Air Resources Board

April 26, 2005

#03-12b

Subject: NUPI – SMARTFLEX re: CARB Approval #03-21a

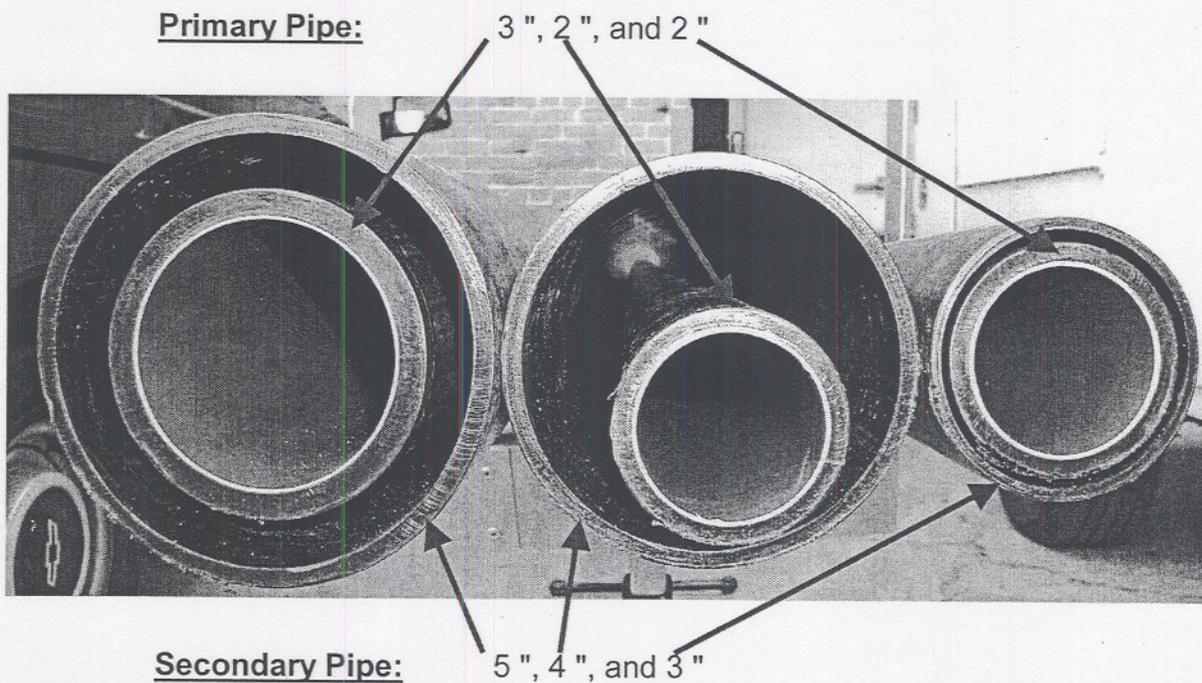
The NUPI pipe system submitted for ARB testing was: TSMA – single wall pipe and TSMAD – double wall, in straight lengths. The NUPI pipe system consists of a high-density polyethylene (HDPE) pipe with an internal organic alloy barrier lining, which reduces hydrocarbon permeation through the pipe (see Enclosure). NUPI fittings (single and double wall) are also manufactured with HDPE. The pipes and fittings are connected by electro-fusion welded joints and have full secondary containment – when NUPI double wall fittings are utilized. **Note:** *Only the NUPI semi-rigid piping that comes in straight lengths has been evaluated for use as vapor return piping.*

SIZE	I.D.	O.D.
Primary	2"	2"	2 1/2"
	3"	2 7/8"	3 1/2"
Secondary	3"	2 5/8"	2 7/8"
	4"	3 7/8"	4 1/4"
	5"	4 1/2"	4 7/8"

Note: A double-wall pipe consists of a primary pipe inside a secondary pipe, while a single wall pipe consists of a primary pipe only. A primary pipe can be recognized by a green internal lining running the length of the pipe.
